**United States Department of the Interior  
California Department of Toxic Substances Control**

December 23, 2014

**Subject:** Directives on Outstanding Issues on the Basis of Design Report/ Pre-Final Design (90% Design) Supplemental Package for PG&E Topock Compressor Station Remediation Site.

***Technical Memorandum from Topock Technical Review Committee  
Design Alternatives – Bat Cave Wash Crossing – Topock Compressor Station  
Groundwater Remediation Project***

View looking downstream of existing crossing CMPs. From PG&E.

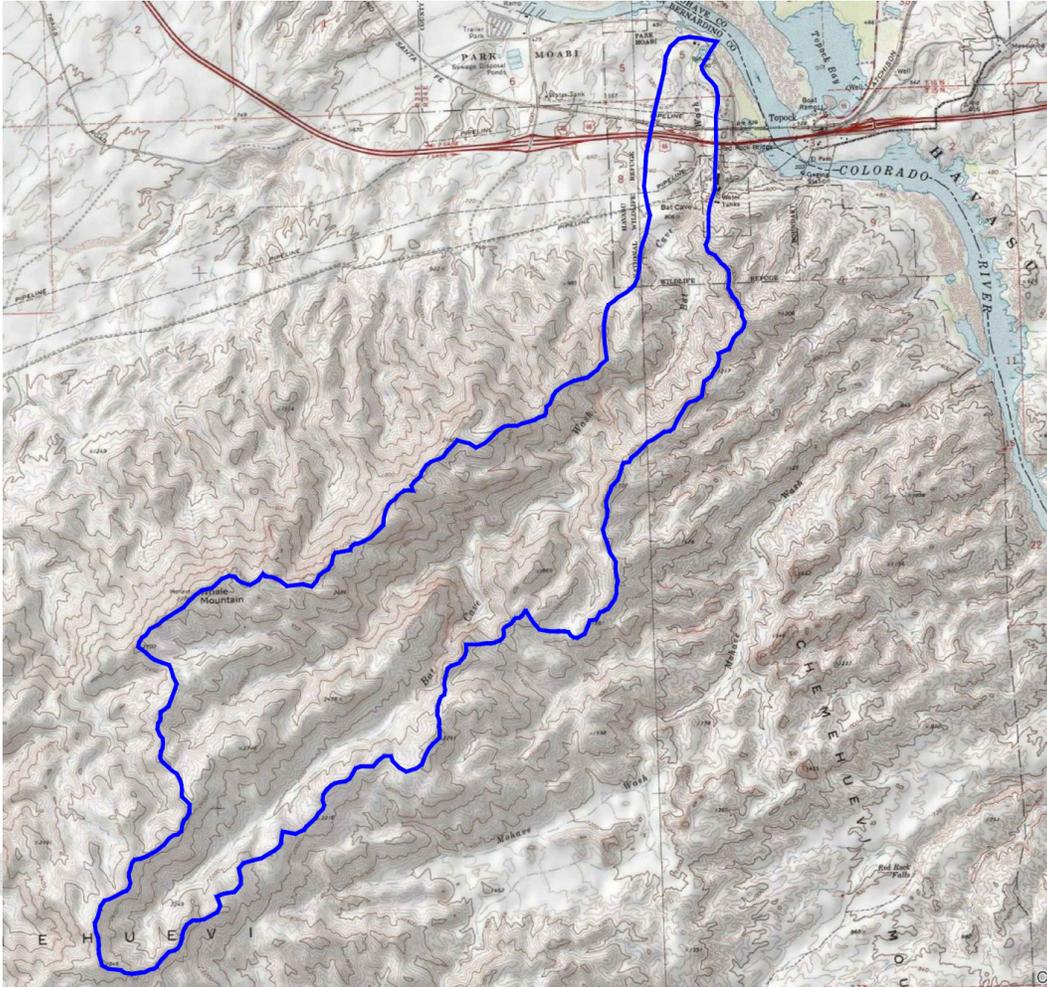
Presently, PG&E is considering a 90% Design alternative for the roadway crossing of Bat Cave Wash along an old un-named alignment of Route 66. Currently, the crossing is culverted, with six 42-inch corrugated metal pipe (CMP) drainage structures, complete with flared end sections and limited embankment erosion protection, which incorporates ungrouted rip-rap and geosynthetic filter fabric. See the image below. Such a crossing is considered to be a “vented” low water stream crossing, as the roadway dips to almost the channel bottom, and drainage structures (the six CMPs) with a modest capacity are provided to pass the low flows.

Visual simulation of a proposed box culvert / bridge replacement for crossing on Bat Cave Wash. Image from PG&E.

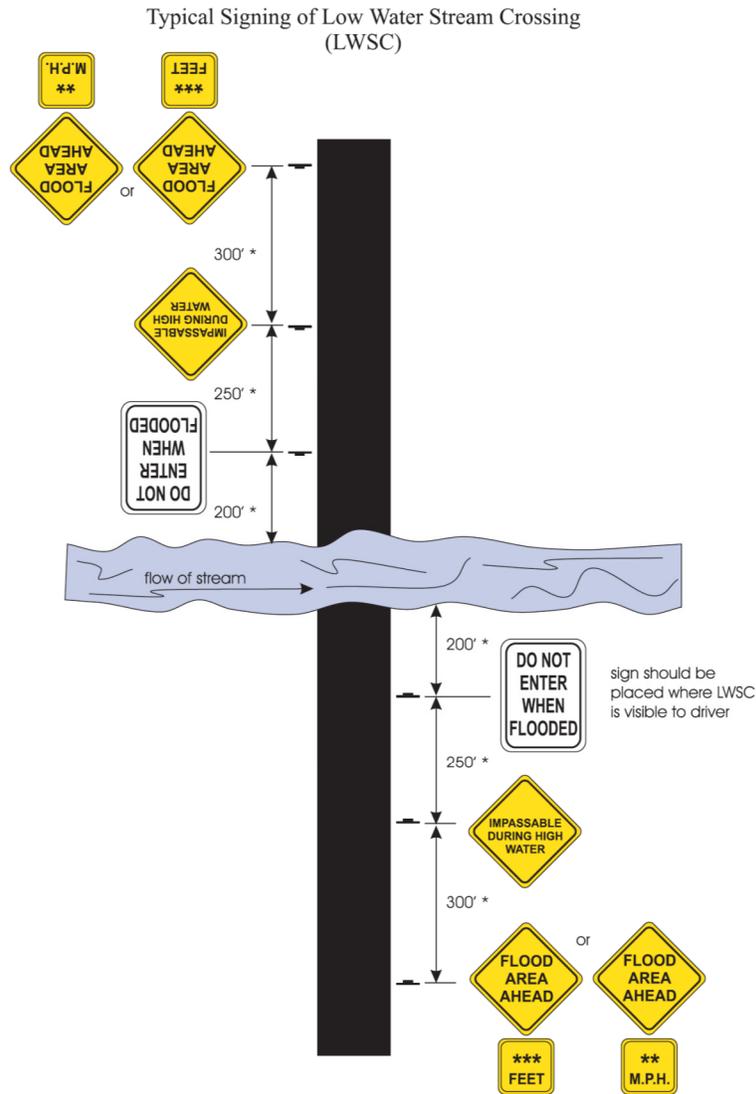
As an alternative to the aerial pipe bridge, PG&E has proposed to replace the CMPs with larger box culverts and a bridge. See the image below (from PG&E) that shows a visual simulation of how this bridge might be designed and constructed – utilizing two 6-ft-high by 20-ft-wide box culverts. The remedy infrastructure would be placed above the box culverts, in the bridge deck. The grade would need to be raised nearly 2-3-ft and the approaches would need to be raised and graded accordingly. We understand that this structure would have an approximate conveyance capacity for flows with a 4% (1 in 25) annual exceedance probability. Storms with lower annual exceedance probability would overtop the structure, which presumably would be armored to endure the higher flows.

- 1) A box culvert / bridge similar to that being considered, with the remedy infrastructure (pipes/conduits) hung on the side of the bridge, or placed under the bridge, in a large-diameter conduit or other structure, to reduce, by approximately 2 feet, the vertical distance that the road grade must be raised.
- 2) Reconstruct the existing culverted drainage structure and place the remedy infrastructure within trench boxes or within a large diameter conduit beneath it, and use grouted rip-rap, or some other armoring method on the upstream and downstream embankment faces.

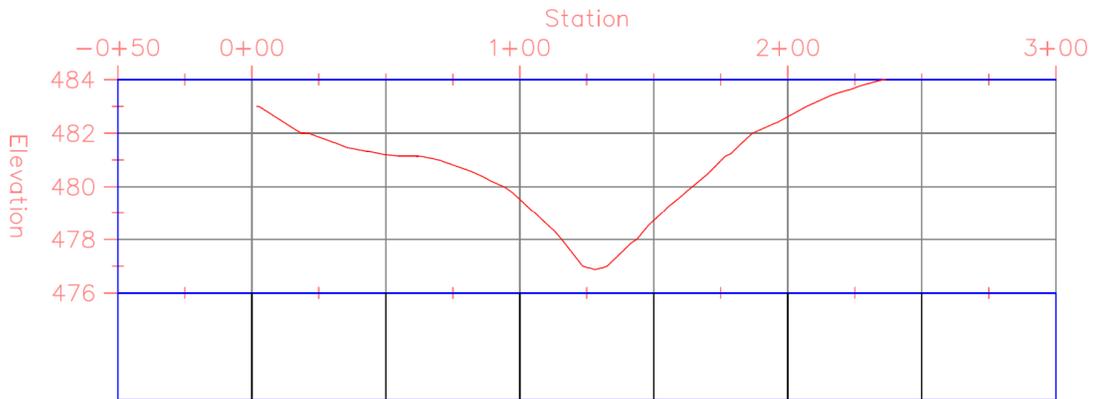
A possible roadway design profile for an unvented low water stream crossing on Bat Cave Wash is shown below, with stationing increasing in an easterly direction, and is based on a Civil 3D drawing pictured in Appendix 1.

Channel profile at existing culverted Bat Cave Wash crossing. Horizontal distances are in stations, and elevations are in feet.

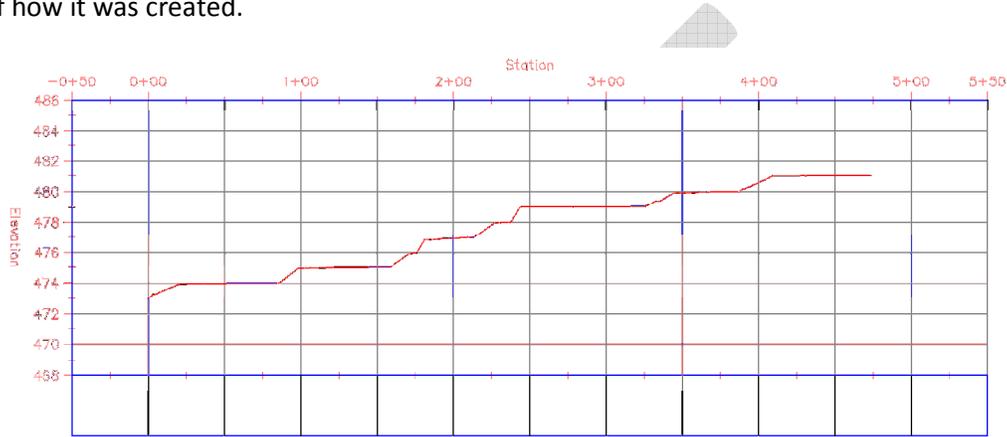
As part of any design, the geomorphology and sediment regime of Bat Cave Wash should be examined, so that the flow line of the drainage at the drainage structure is set appropriately. An approximate profile of the existing condition along the channel is shown below – with the existing crossing at approximate station 2+00 (200 ft), and with stationing increasing from downstream to upstream – the alignment for this profile is shown on the Civil 3D drawing in Appendix 1. Due to the limited number of contours available in the drawing used to generate this profile, the channel profile appears stepped – an artifact of how it was created.

**PIPELINE "A" - PLAN**

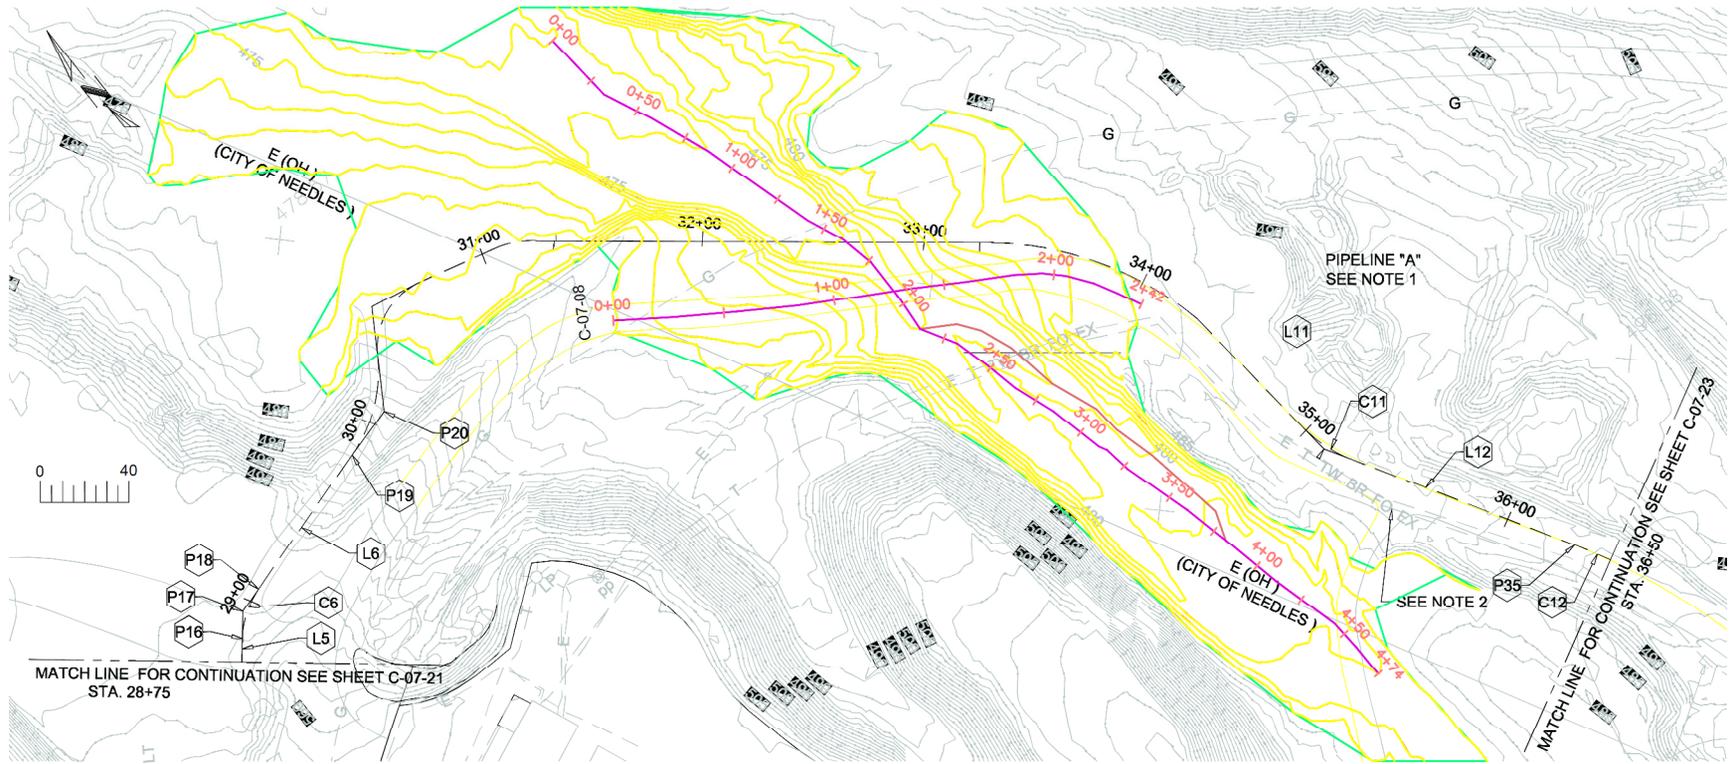
Civil 3D drawing with profile alignments along former Route 66, and along Bat Cave Wash. The 90% Basis of Design Report Pipeline A alignment with approximate stations running from 29+00 to 36+00 is indicates, as are alignments for profiles of an unvented low water stream crossing (with stations ranging from 0+00 to 2+42) and the Bat Cave Wash channel in the vicinity of the crossing (with stations ranging from 0+00 to 4+74). This drawing was created using a PDF plan sheet from the 90% Basis of Design Report.
